VALUE ENGINEERING CHANGE PROPOSAL MISSOURI DEPARTMENT OF TRANSPORTATION

Contract ID 130125-F01 **Job No.** J6I2412

County St. Charles **Route** 70 **Original Contract Amount** \$12,409,196.96

Wall 13-2412-002 (Ramp 1/1A, Sta. 7+50 to Sta. 11+50)

| | PERMANENT CONCRETE TRAFFIC BARRIER TYPE C AS RETAINING WALL |

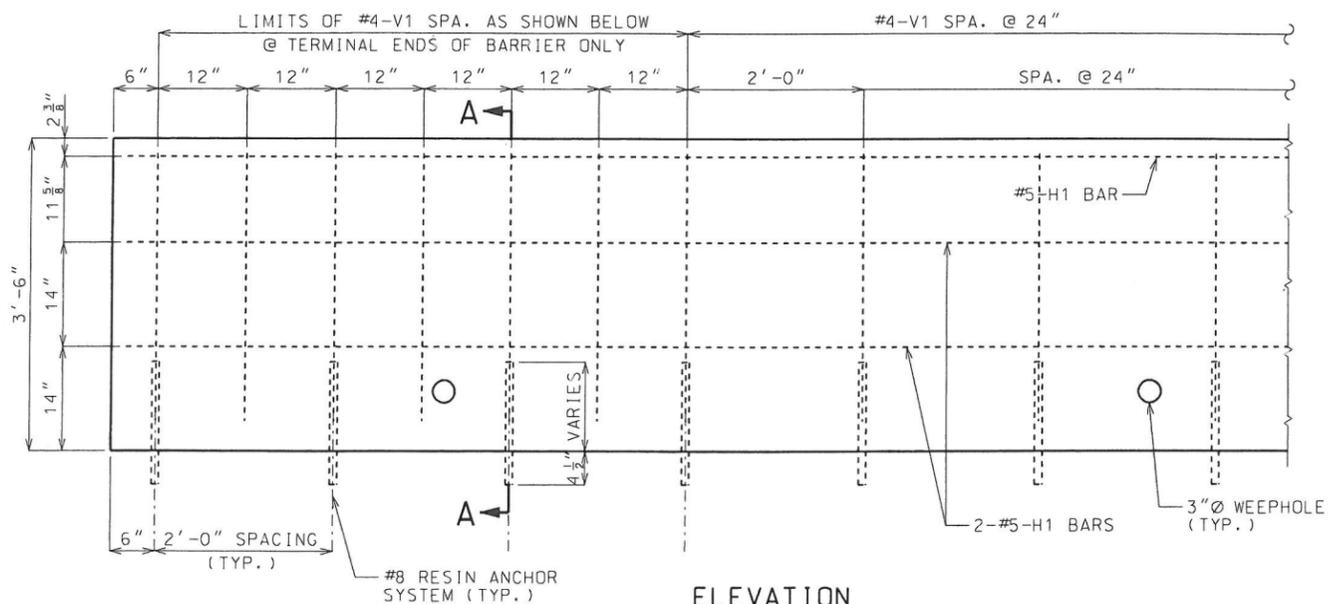
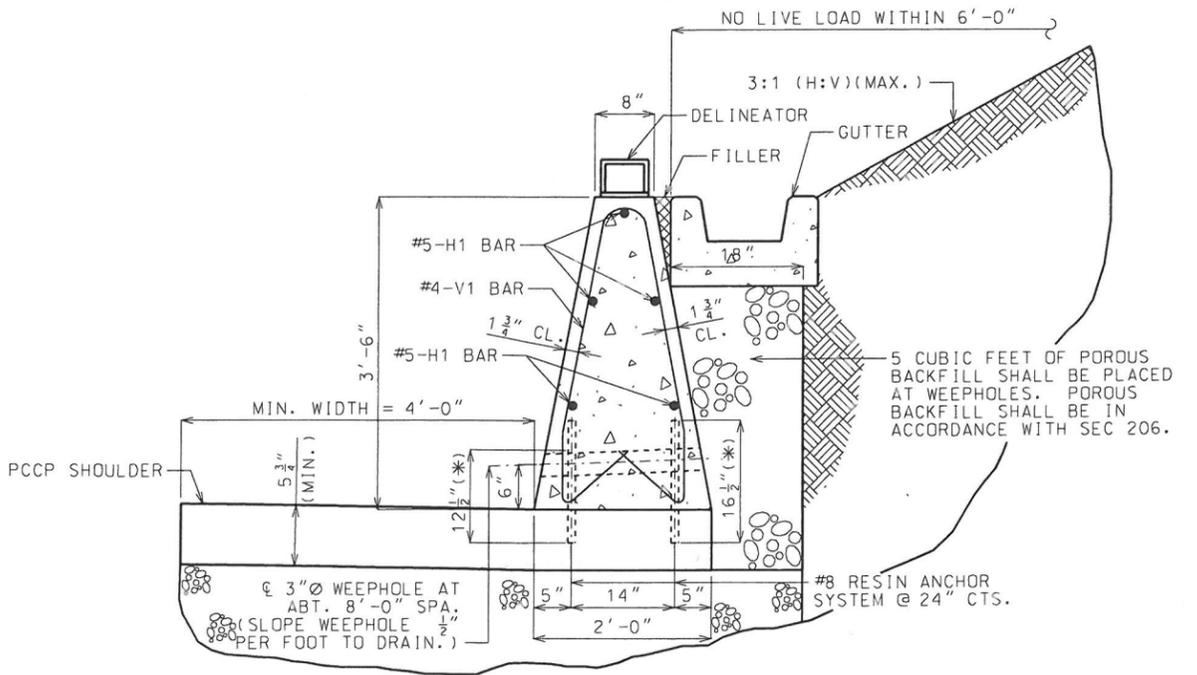
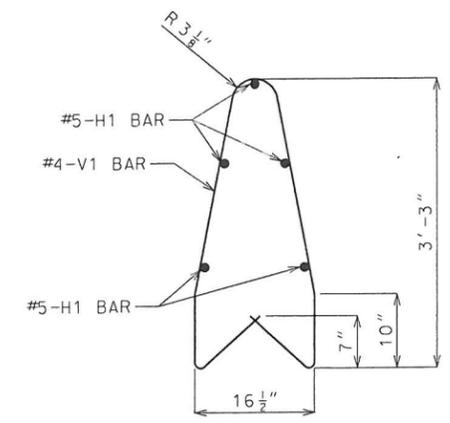
The proposed concrete barrier wall will be a Type C (Retaining Wall) and include the PCCP shoulder slab as shown in MoDOT standards. The existing parking lot will be saw cut along the proposed alignment and excavated for the PCCP shoulder slab. The barrier wall will include a Type B Gutter on the back side. The Concrete Traffic Barrier Type E shown to be placed along Ramp 1 will be substituted with Guardrail Type A, 7' Posts, 3' Spacing and allow for an A2 Shoulder in place of the A1 Shoulder.

PROPOSED TYPE C BARRIER WALL

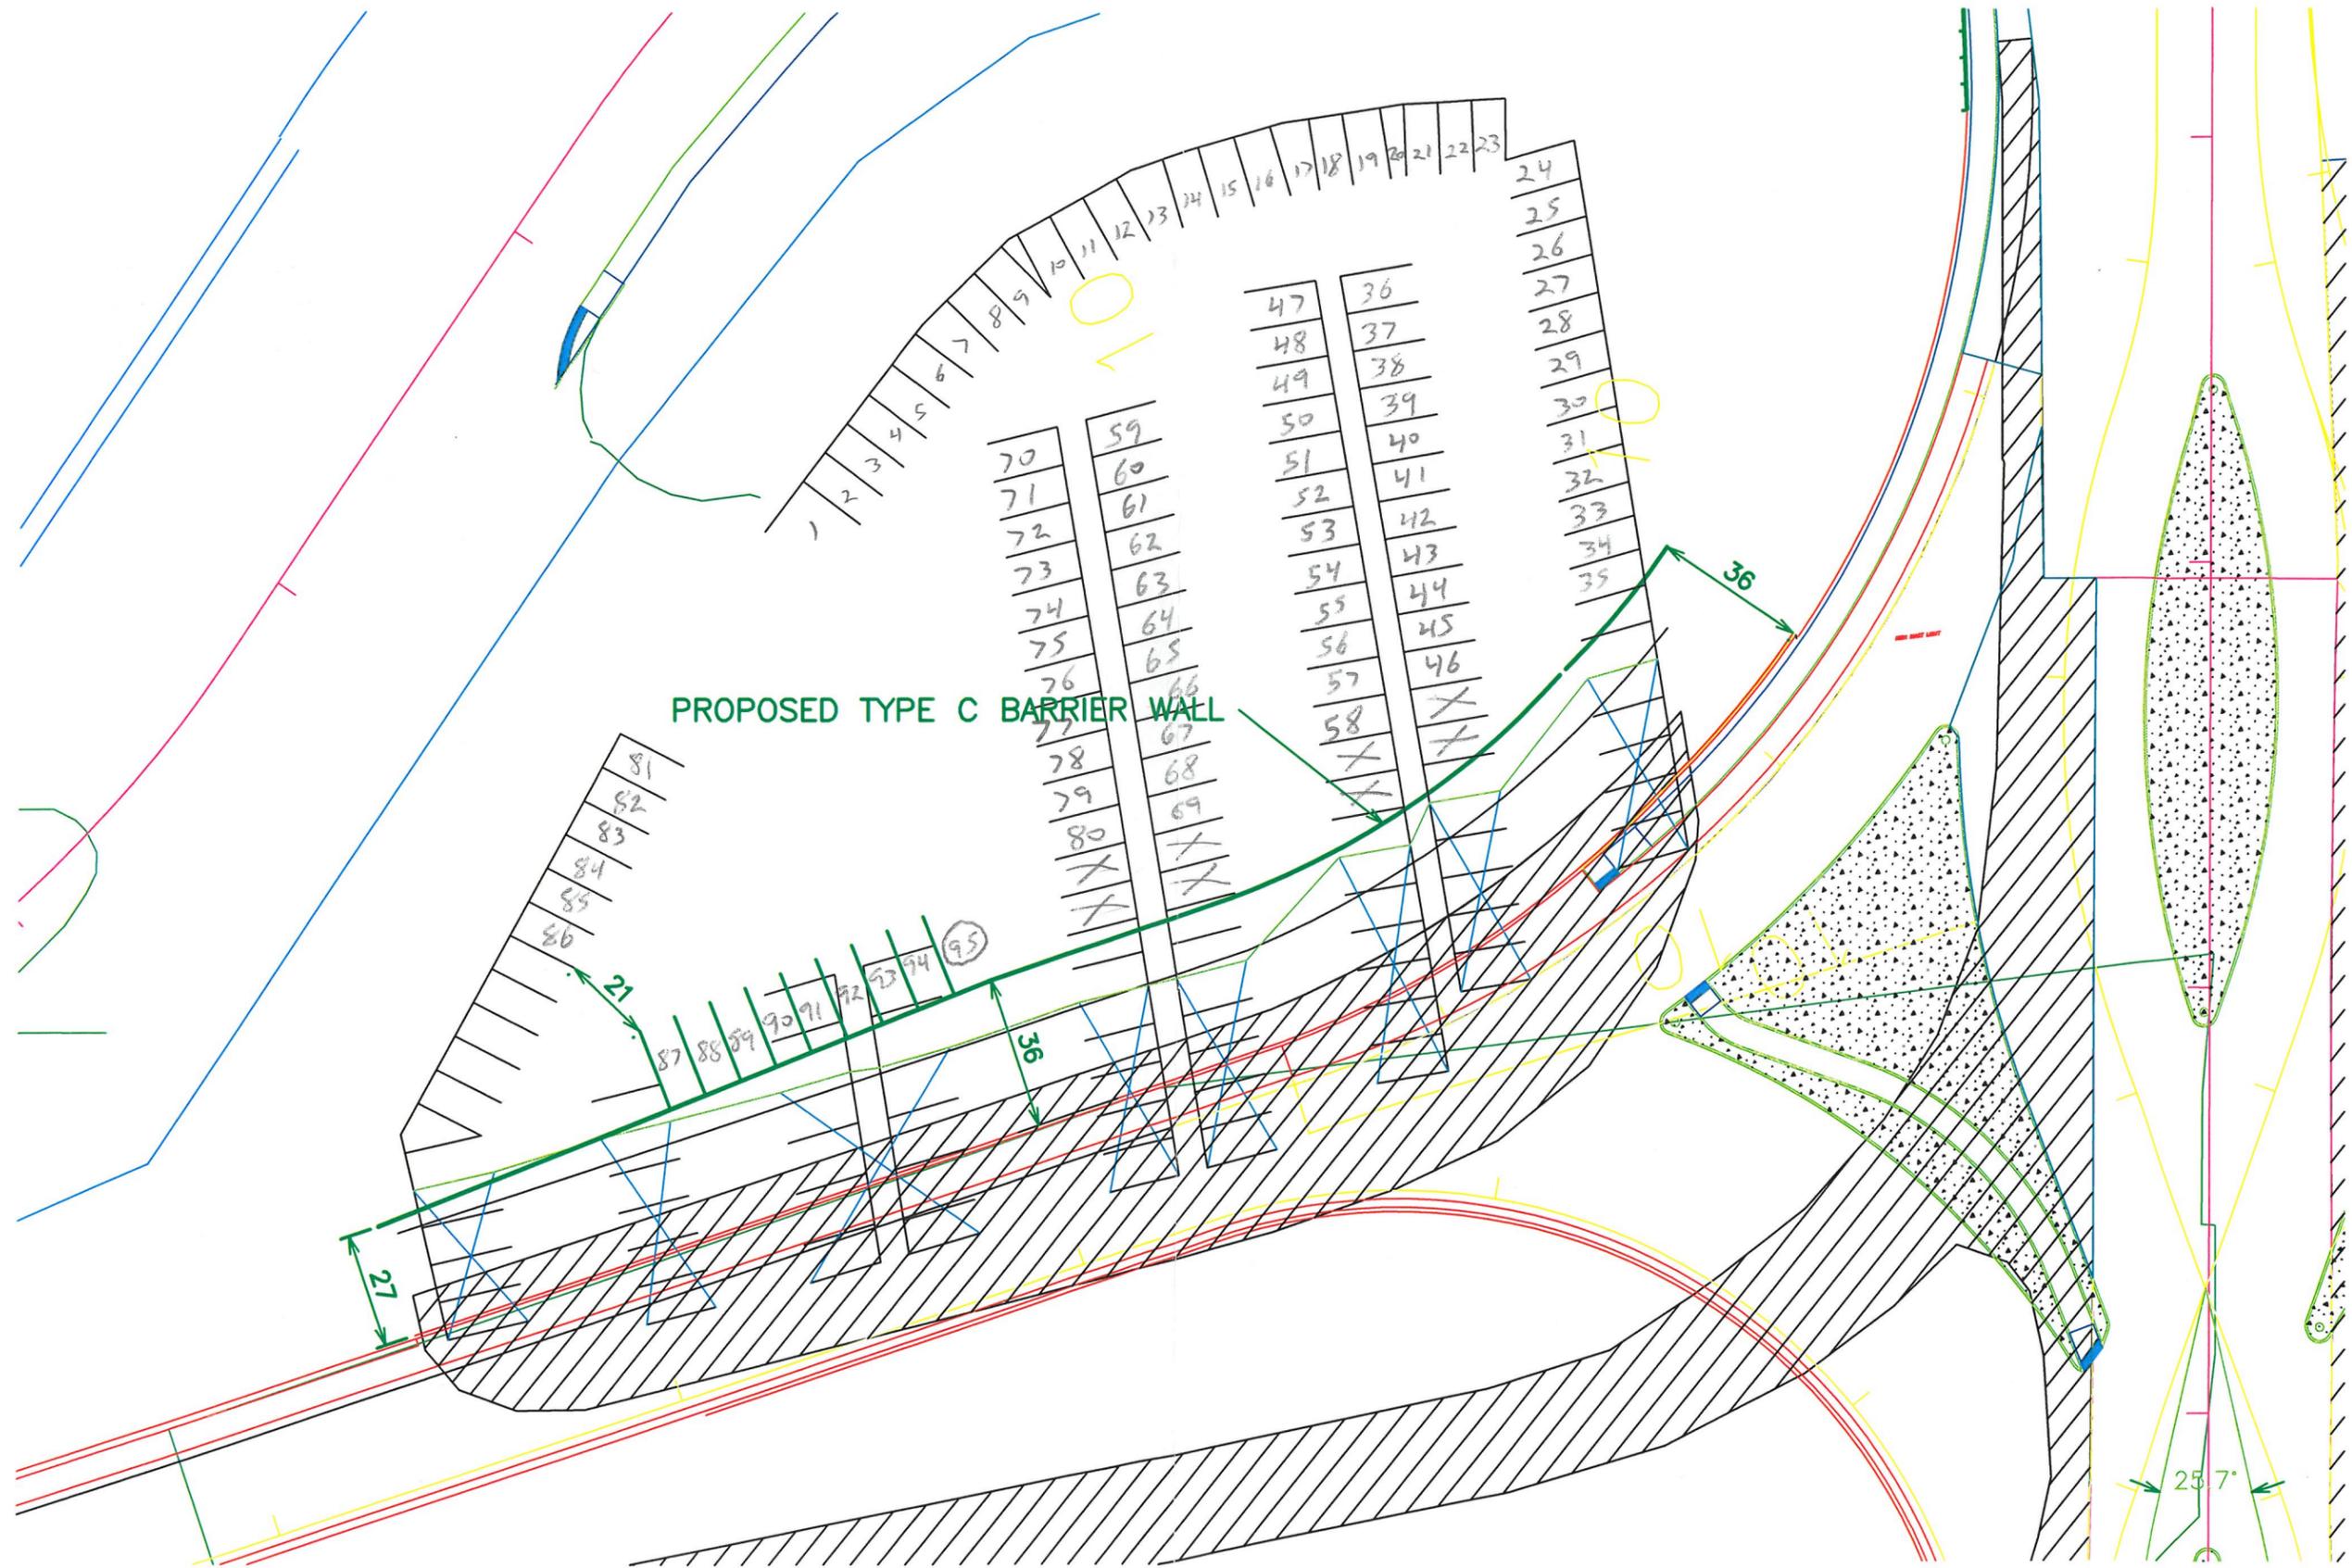
The current plans show constructing an MSE Wall along Ramp 1, adjacent to the Commuter Parking Lot and the proposed change is to substitute MSE Wall 13-2412-002 with a Type C (Retaining Wall) concrete barrier. The proposed barrier wall would be offset 27'-36' from the MSE Wall location, extending the 3:1 slope towards the parking lot. The proposed location of the concrete barrier wall will leave a minimum of 95 parking spaces. If additional spaces are desired, the parking layout in the southwest corner can be adjusted in the field to maximize the spaces. See attachments for additional details.

Comments: After review and comments from the St. Charles Area team, I recommend approval of this VECP. The contractor is providing an acceptable number of parking spaces for the commuter lot, as well as an acceptable barrier wall and adjacent slope. If the commuter lot needs to be restriped, the lot will first be overlaid with BP-1.

RMP 1
7+50.00 / 2

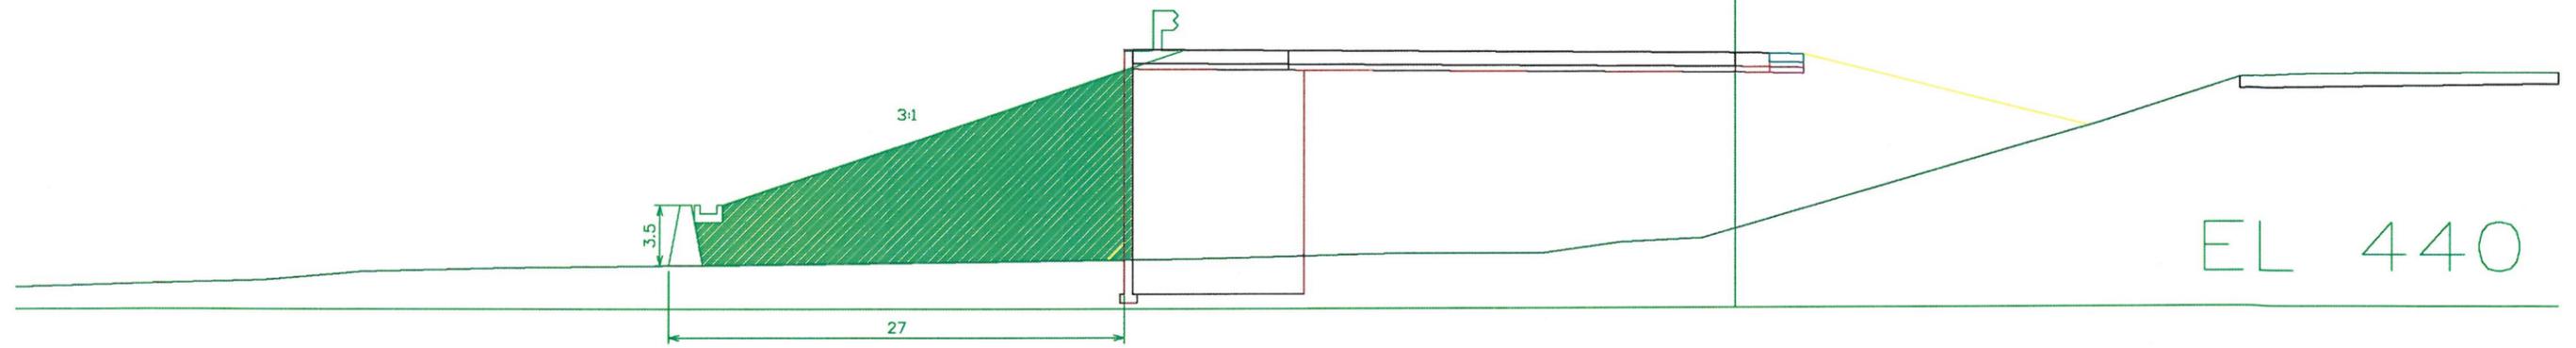
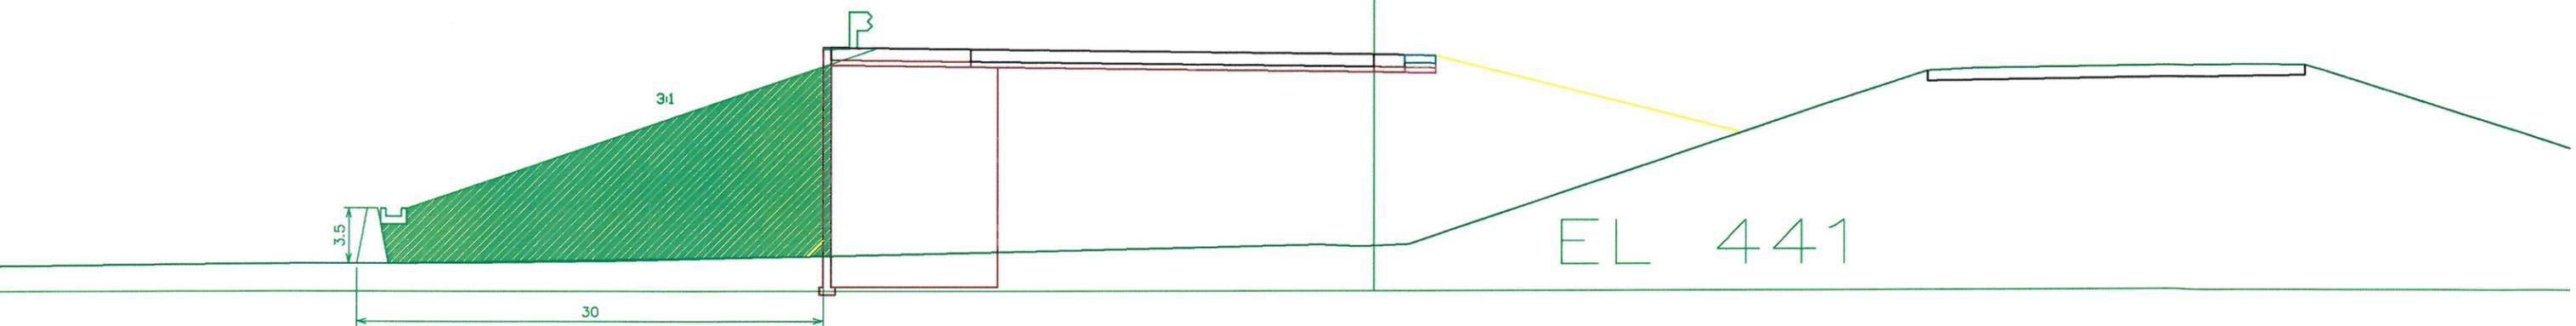
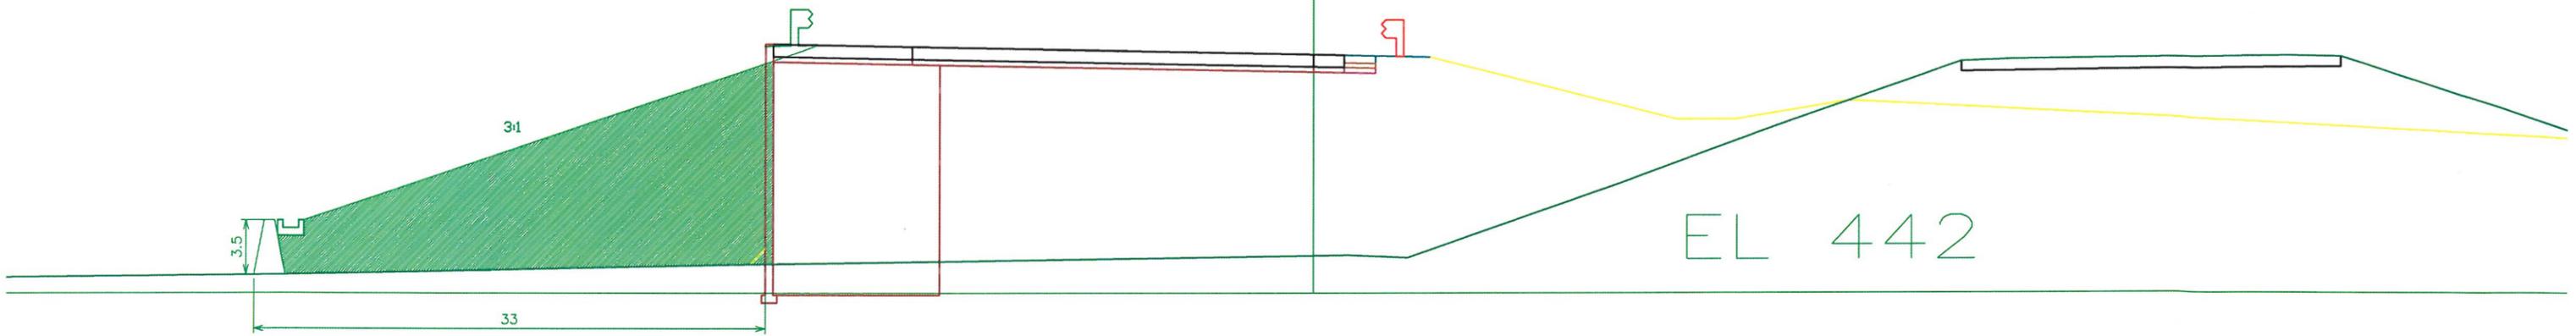
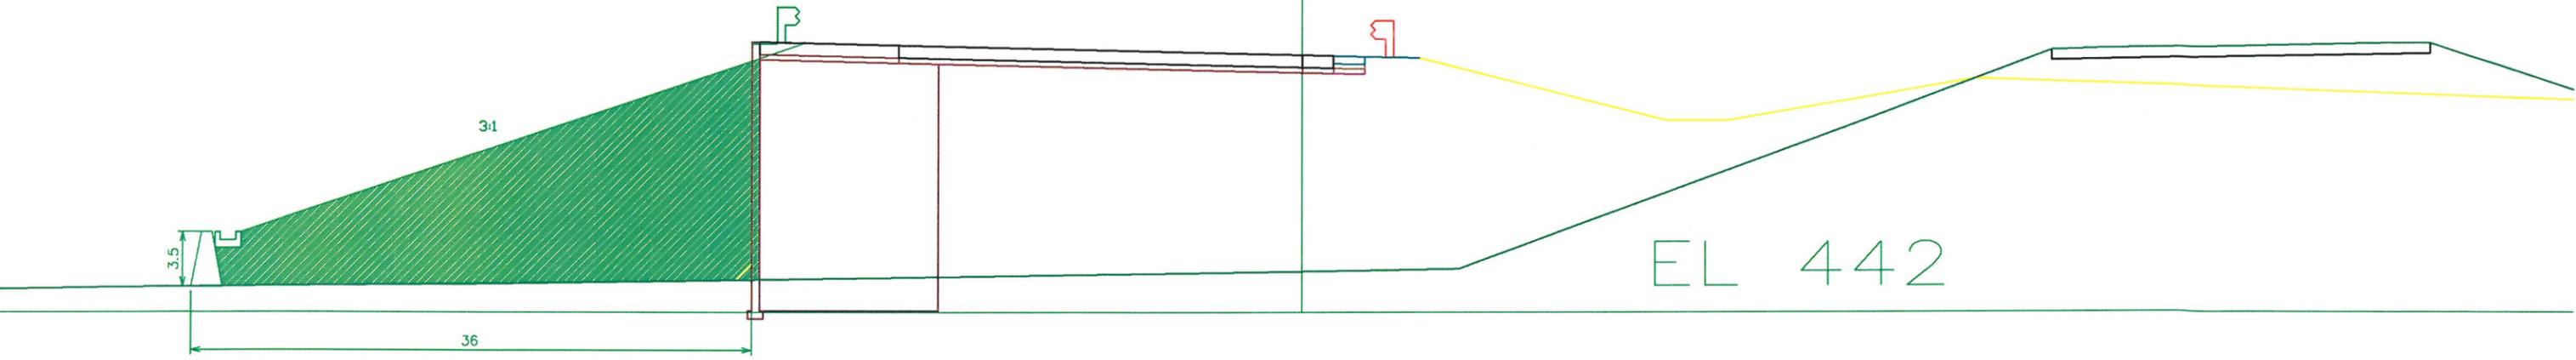
- Itemized breakdown
- Plan sheet showing proposed barrier wall and revised commuter lot spaces
- Barrier wall detail (MoDOT standards)
- Revised cross sections
- Excavation/Embankment Volumes
